ATS 171102 Version 1

MIL On with DTC P0035?

2017 Civic Type R

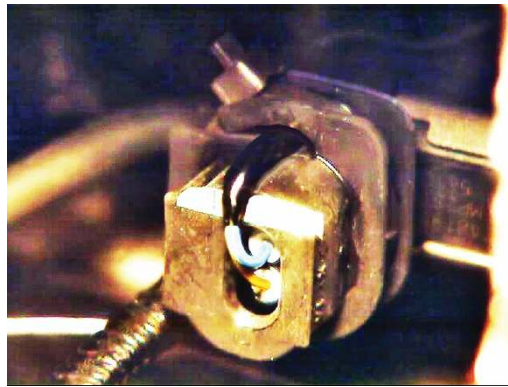
Is the MIL on with DTC P0035 (turbocharger bypass control solenoid valve circuit high), and you're seeing **Rev Match System Problem** and/or **Emission System Problem** in the driver information interface? A broken wire(s) in the turbocharger bypass control solenoid valve 2-pin connector is the likely cause.

We found that when the connector matches a natural engine frequency, it starts to oscillate. Over time, this can cause one or both of the connector wires to break, resulting in a short. And if they do break, you might not even notice it if the insulation remains intact.

If this is the case, **don't** try repairing the broken connector wire(s). Even if you manage to, they're still prone to oscillation, and you could wind up with a comeback.

Instead, replace the engine wire harness with **P/N 32110-5BF-A02**. This replacement harness has a more robust turbocharger bypass control solenoid valve connector. So far, we haven't seen any reports of comebacks from using this harness.
